July 13, 2005

This is reference to the final Office Action for Application No, 10/621,487 Art Unit 3676. Please let me discuss Frey's Patent No. 1,034.008, dated July 30, 1912, by which you have rejected my patent locking claims.

Fig. 6 - 7 (a,b and c = 120 degree)

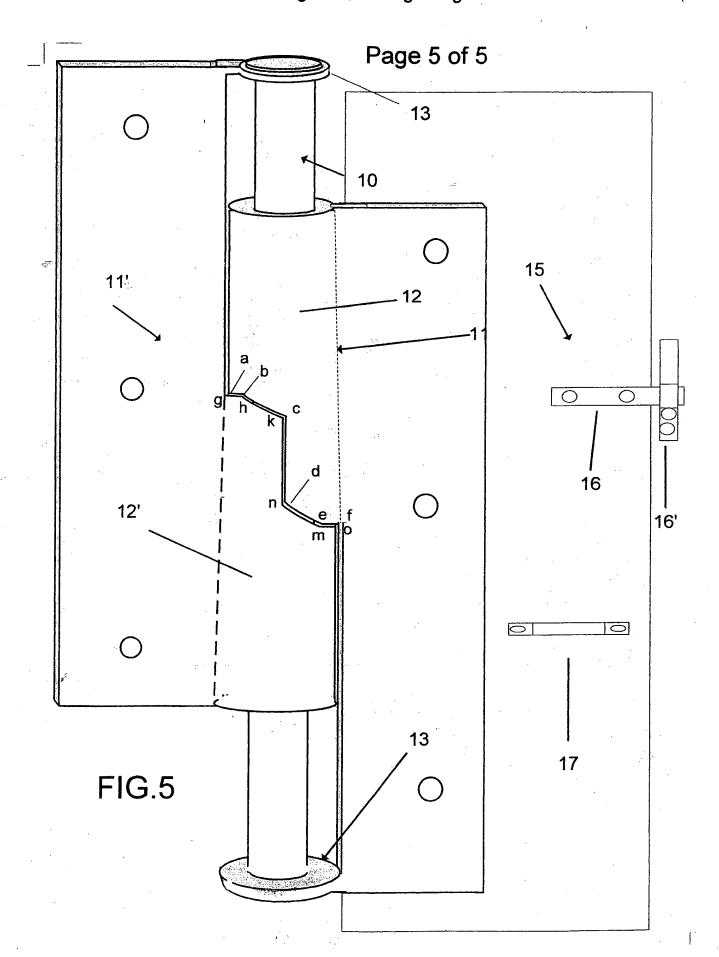
Frey's drawing Fig.6 (part 13), and Fig. 7 (part14), which are the base of his invention should complement each other, it never do so. They do not fit each other. I actually made a prototype of his figure. If one plane was made a complement of the other, then it will act as one-way self-closing hinge, as he claimed. Frey's drawings, on which you are rejecting my invention, is incorrect.

Frey's drawings are based on imagination not on prototype .

Frey's 13 (a) is 140 degree how it could fit to 14(b)=40 degree 19(a)=14(a) 13(b)=14(b)

Fig. 6 or one of them should be like This The complement

(3(a) = 1.4(b)

13(b) = 14 (a)

13(c) = 14 (c)

Fig. 6 - 7 (a,b and c = 120 degree)

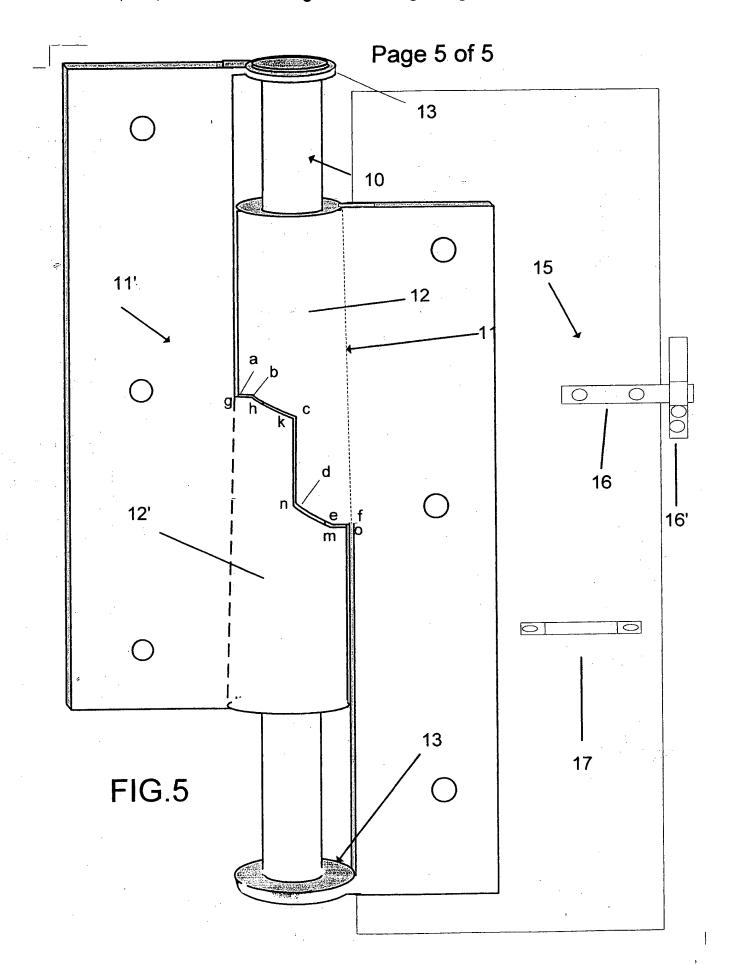
Frey's drawing Fig.6 (part 13), and Fig. 7 (part14), which are the base of his invention should complement each other, it never do so. They do not fit each other. I actually made a prototype of his figure. If one plane was made a complement of the other, then it will act as one-way self-closing hinge, as he claimed. Frey's drawings, on which you are rejecting my invention, is incorrect.

Frey's drawings are based on imagination not on prototype,

Frey's 13 (a) is 140 degree how it could fit to 14(b)=40 degree 13(a)=14(a) 13(b)=14(b)

Fig. 6 or one of them should be like This The complement

This formula control's 13(a) = 14(b) 13(b) = 14 (a) 13(c) =14 (c) to fit together
